**BEFORE HEARING COMMISSIONERS
FOR THE PALMERSTON NORTH CITY COUNCIL**

IN THE MATTER of proposed Plan Change I: Increasing Housing
Supply and Choice to the Palmerston North District
Plan

**SECTION 42A TECHNICAL REPORT OF SARAH JENKIN
ON BEHALF OF PALMERSTON NORTH CITY COUNCIL**

Dated 25 July 2025

Figure 2: Distance between Linton Army Camp and MRZ boundary (source: extract from PNCC GIS, 11 April 2025)

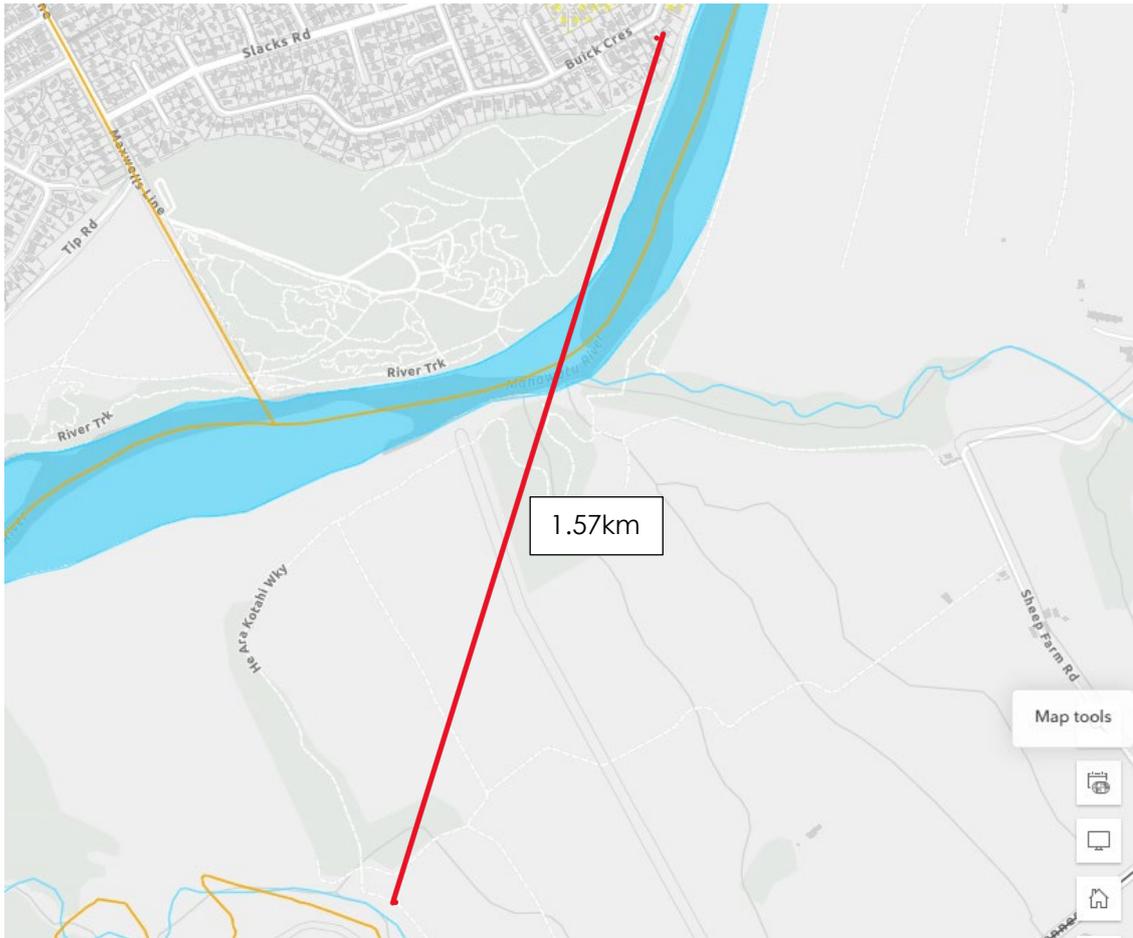
194. The New Zealand Defence Force (NZDF) (SO202.2) seeks to amend MRZ-O5 so that effects of development on infrastructure and physical resources of regional or national significance are avoided. I have sympathy for the NZDF's position – there is an increasing tension between ongoing operation of existing regionally and/or nationally significant infrastructure and residential intensification and generally support the inclusion of controls in a district plan which manage the potential for reverse sensitivity issues and conflicts. However, I disagree with NZDF that Linton Army camp is located “*in the vicinity of proposed medium density residential zoning*” and therefore that a reverse sensitivity issue may arise.

195. There is nearly 1.6km between the closest edge of Linton Army camp and the boundary of the MRZ at Akaroa Avenue (See Figure 2). I do not consider this to be ‘in the vicinity of’. I consider MRZ-O5 as notified gives effect to the RPS (as confirmed by Horizons in SO194.18) and it provides appropriate protection against adverse reverse sensitivity effects. I therefore recommend rejecting SO202.2 and accepting FS06.42.
